P&Z CASE # SP2022-026 P&Z DATE June 14, 2022 CC DATE June 20, 2022 Approved/Denied

SP2022-026: Site Plan for Qdoba

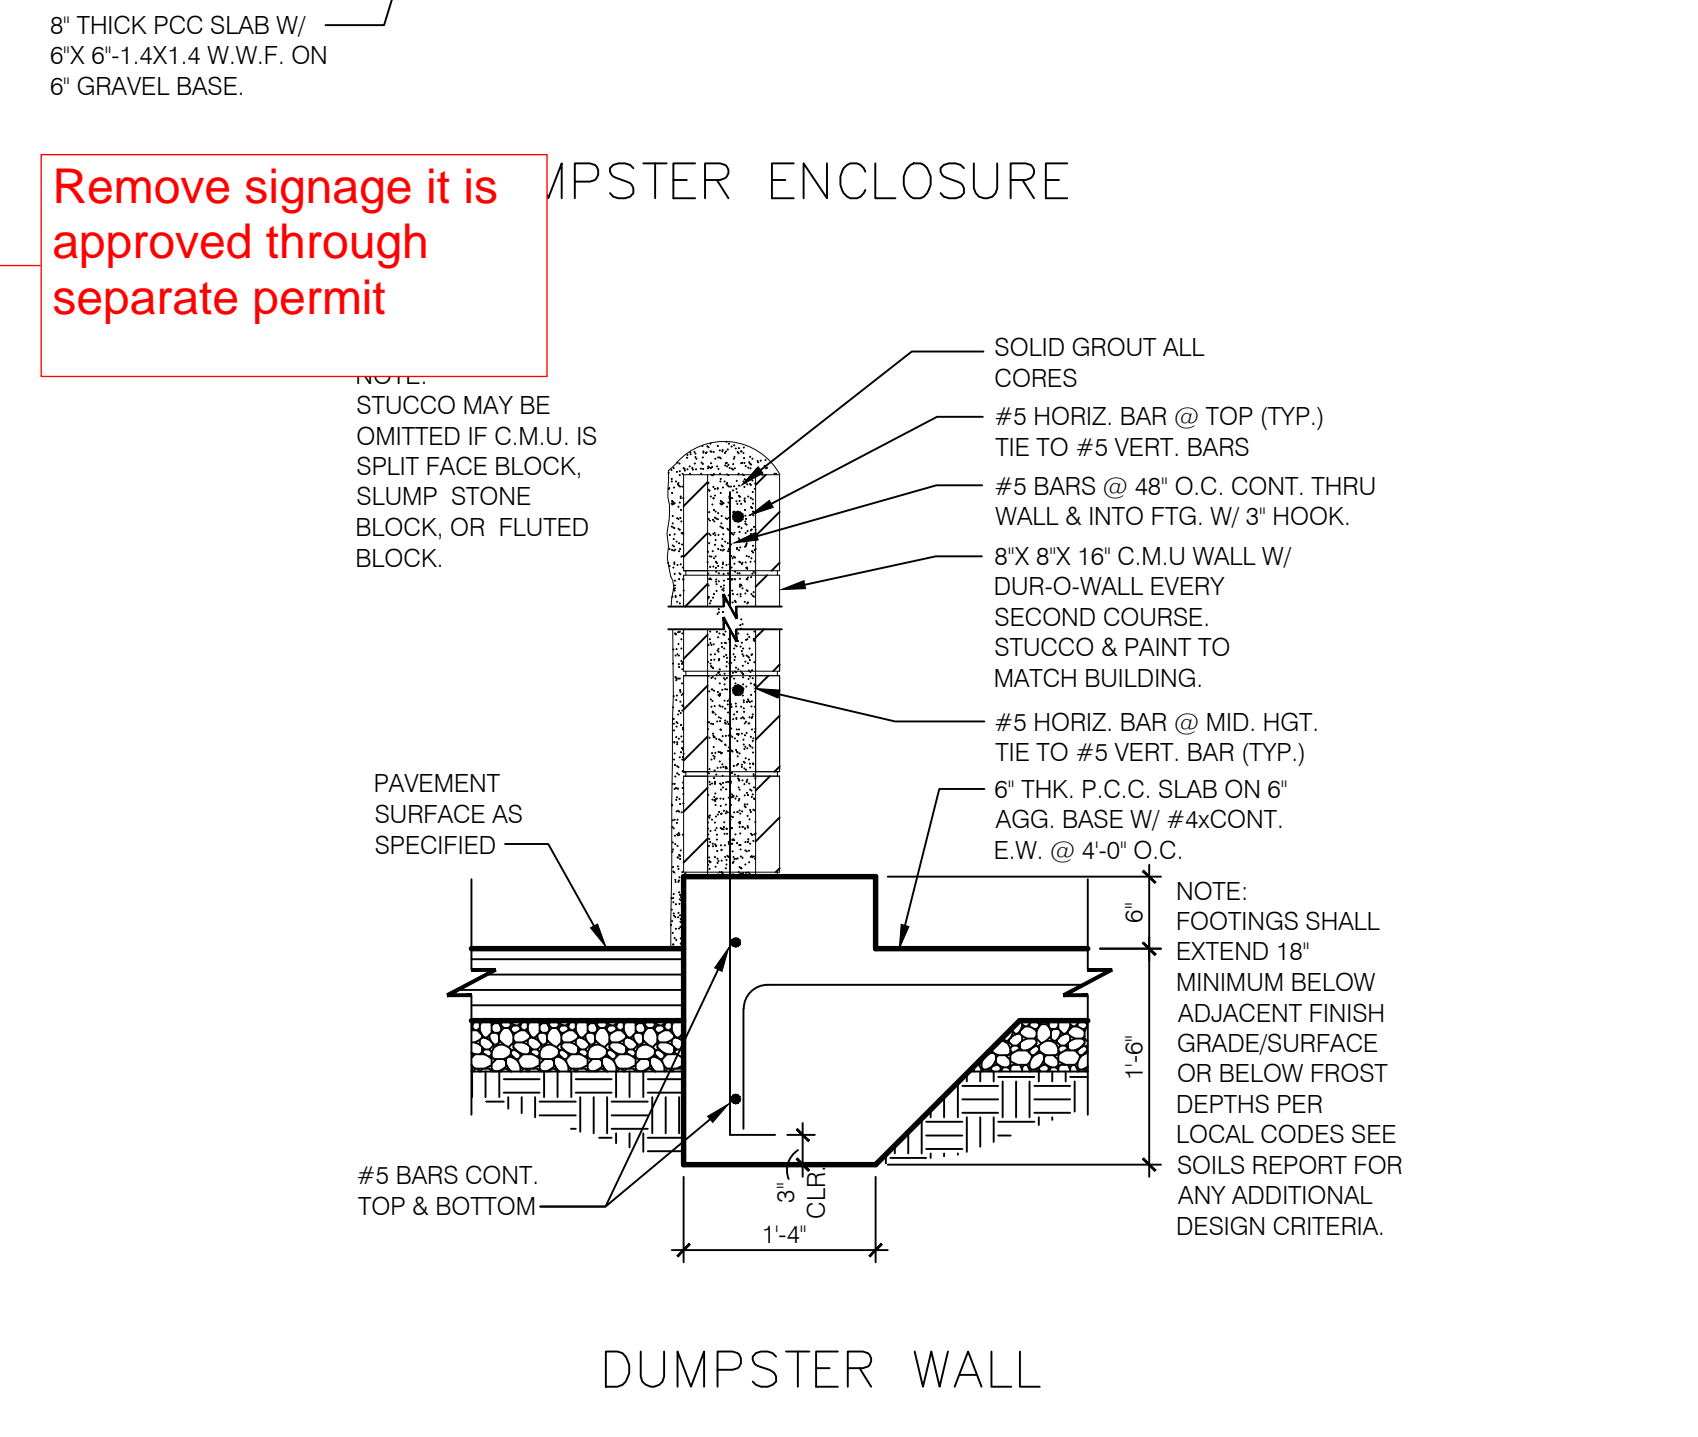
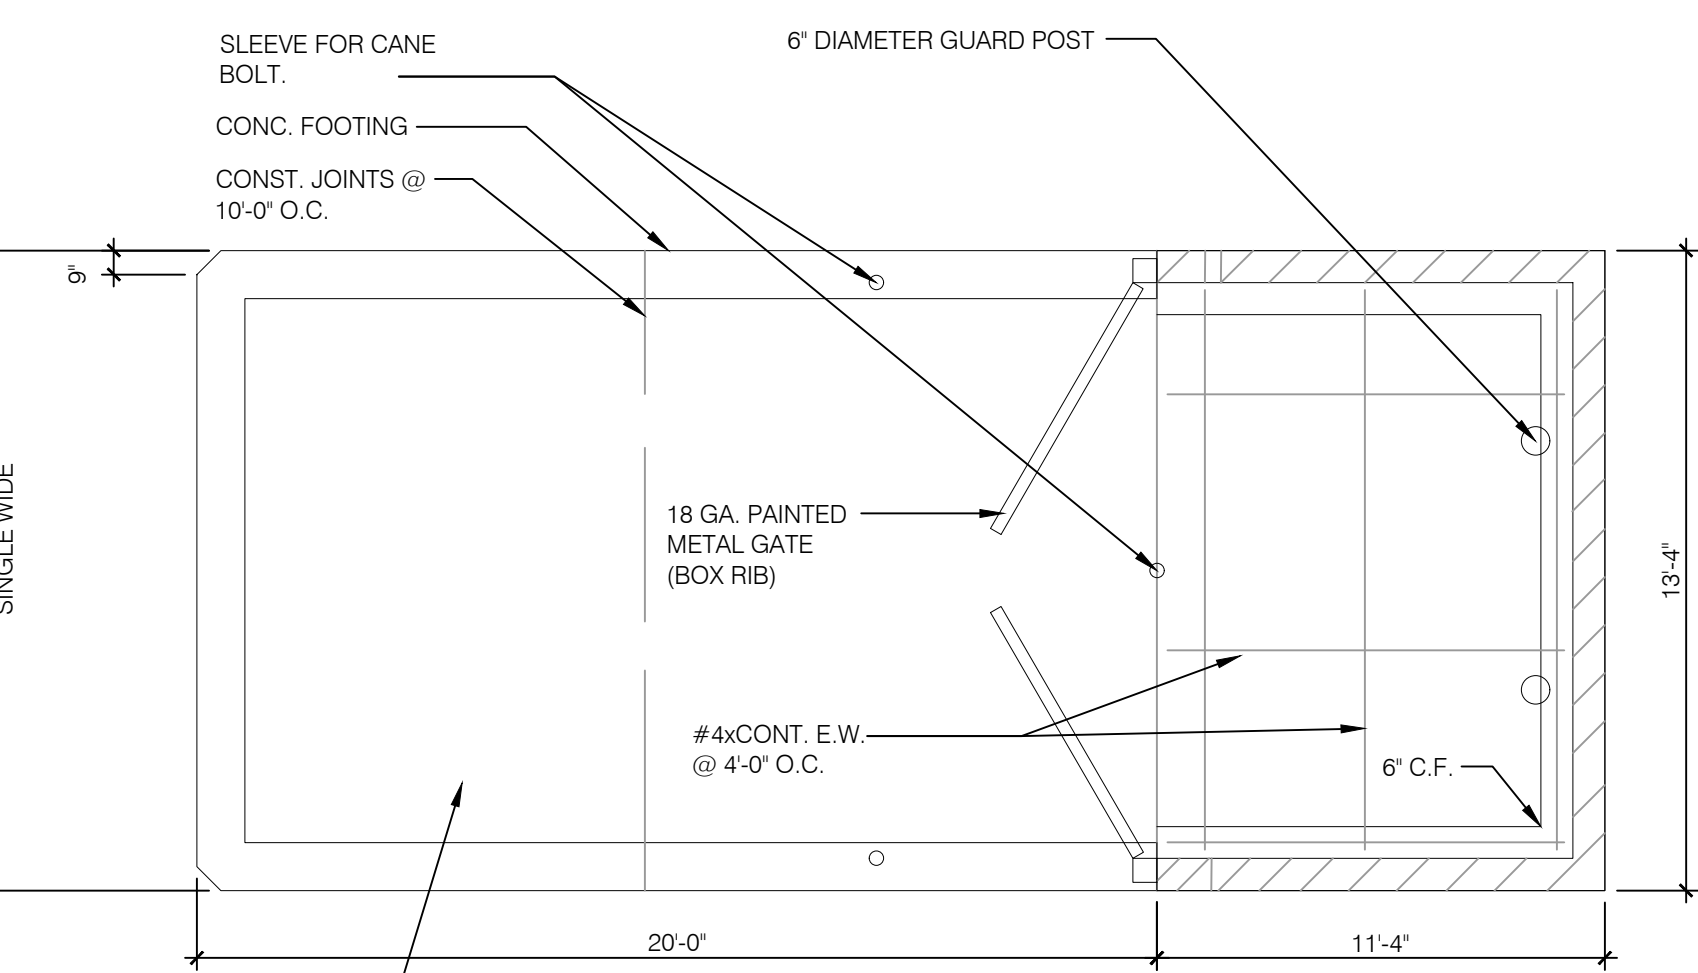
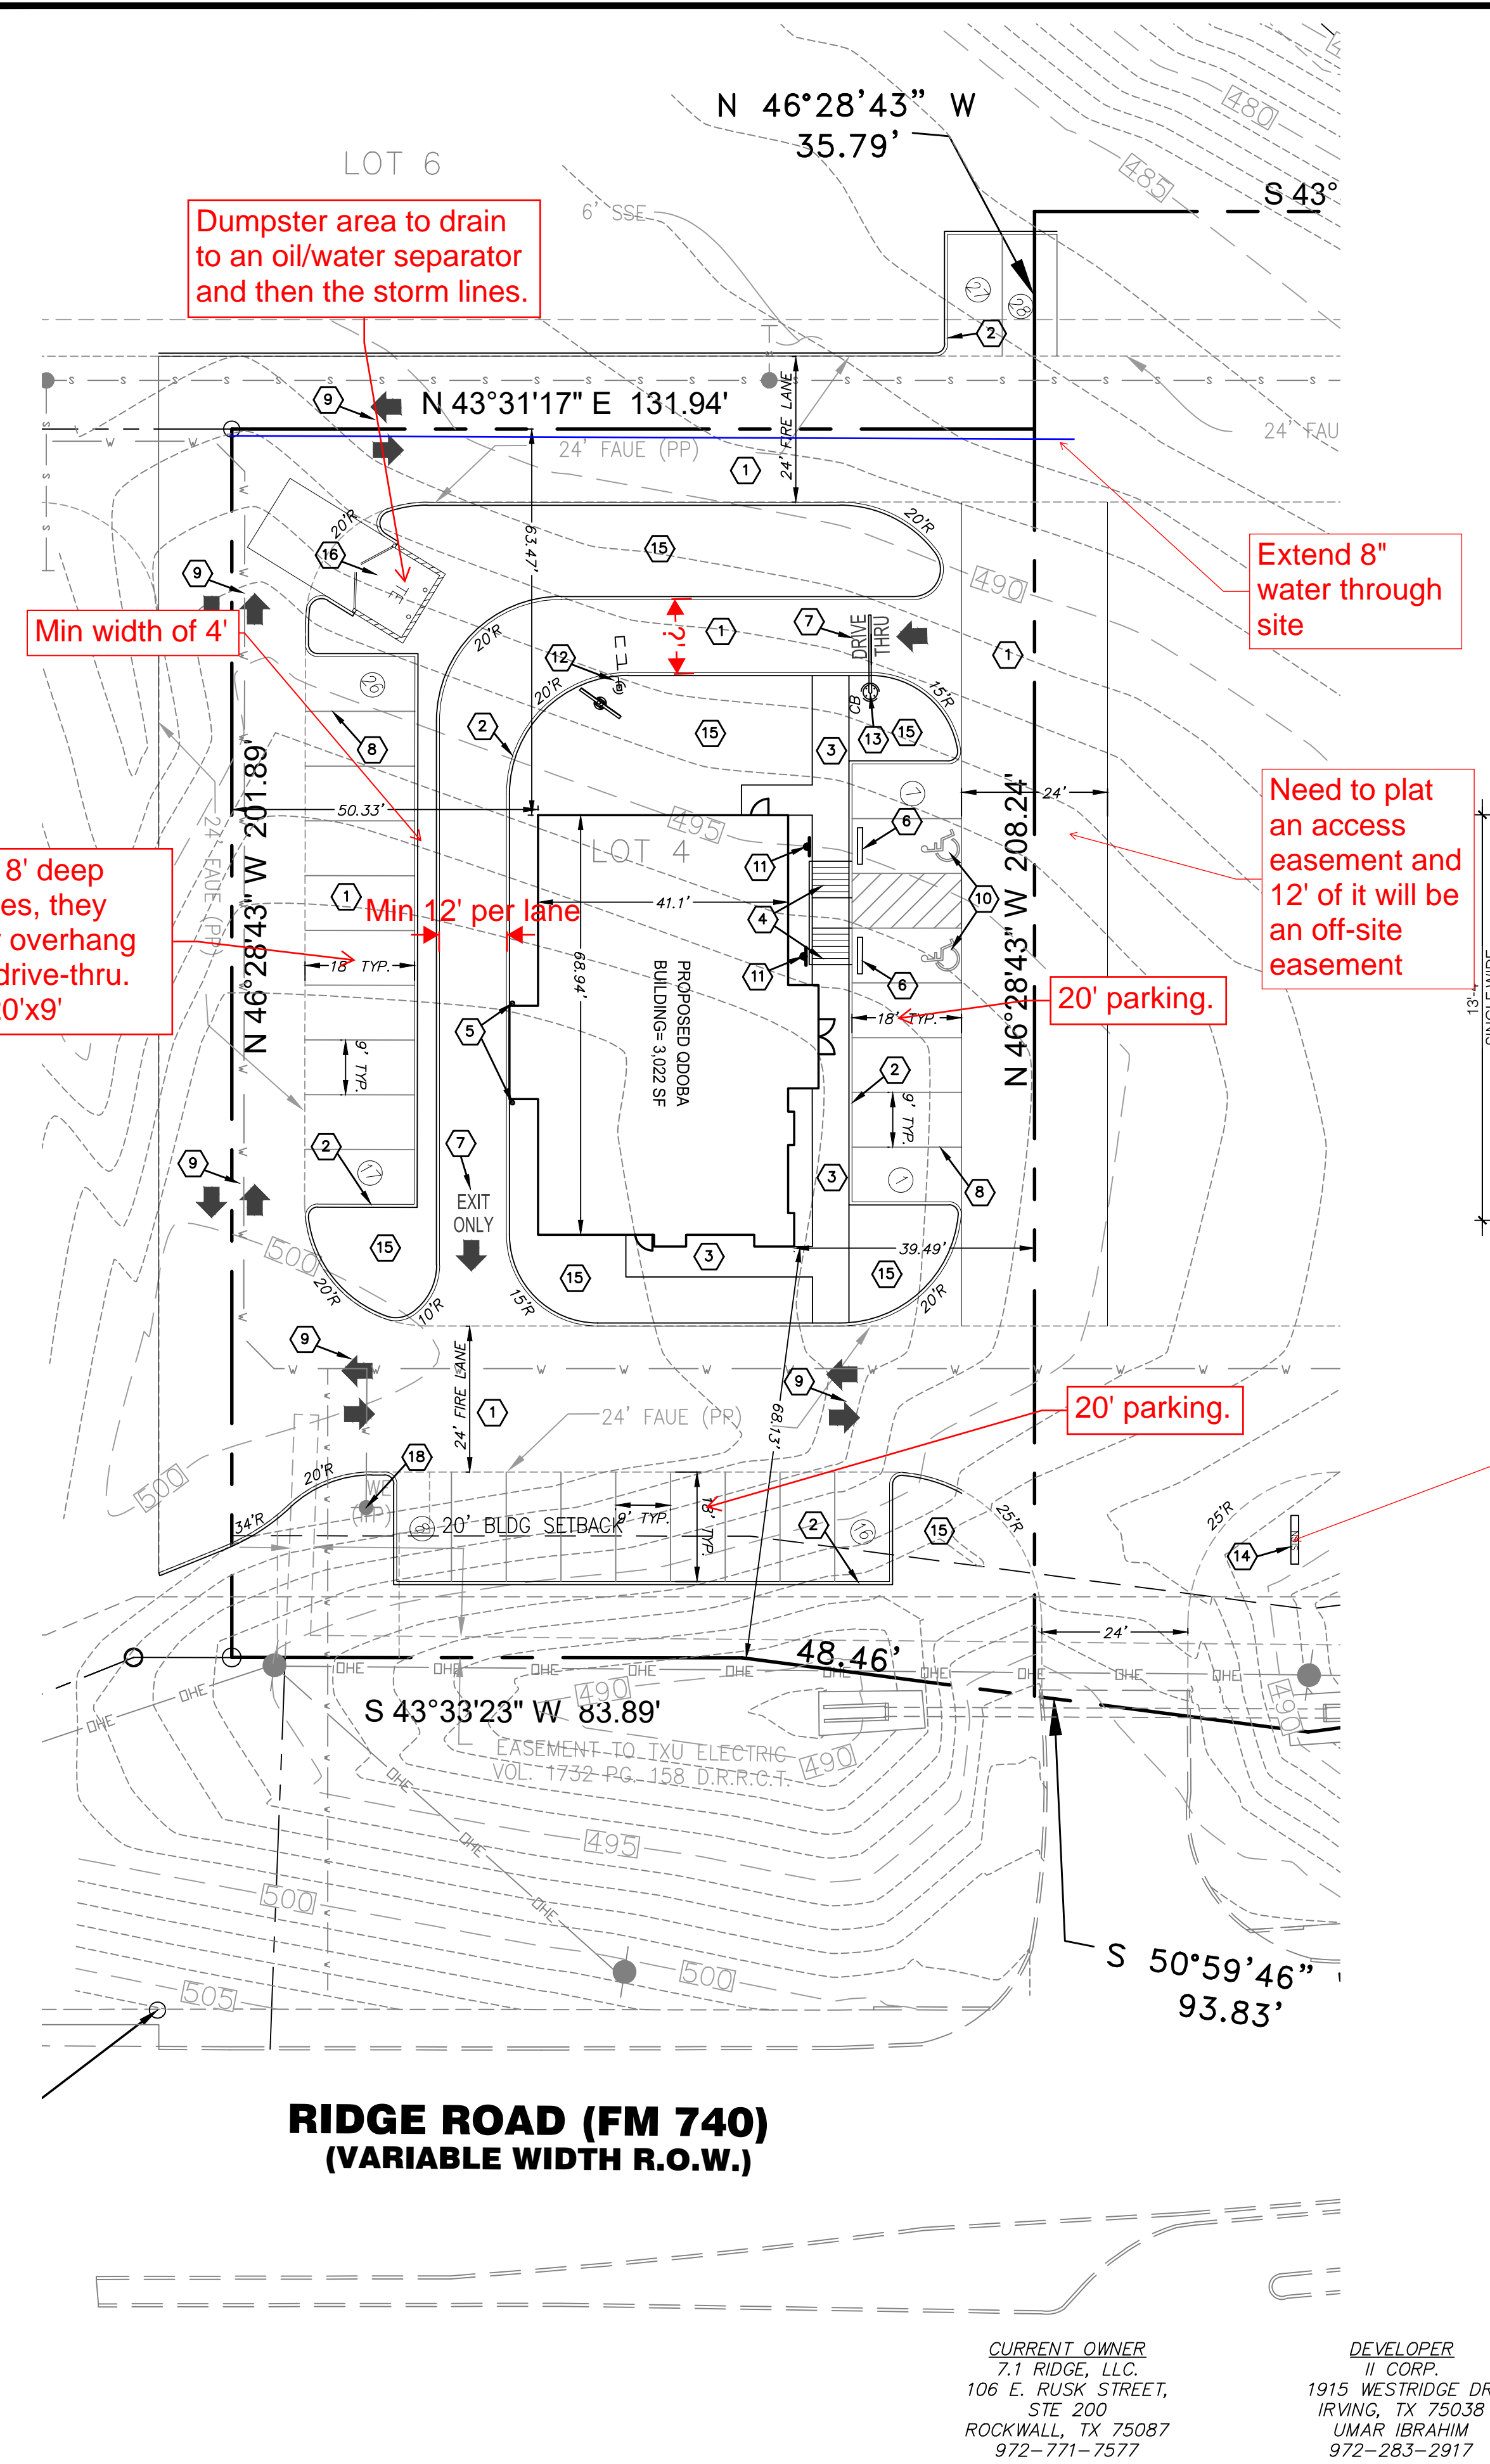
DEPARTMENT	REVIEWER	DATE OF REVIEW	STATUS OF PROJECT
PARKS	Travis Sales	05/23/2022	Approved w/ Comments
05/23/2022: All shade trees must be 4" caliper minimum please change the 3" caliper
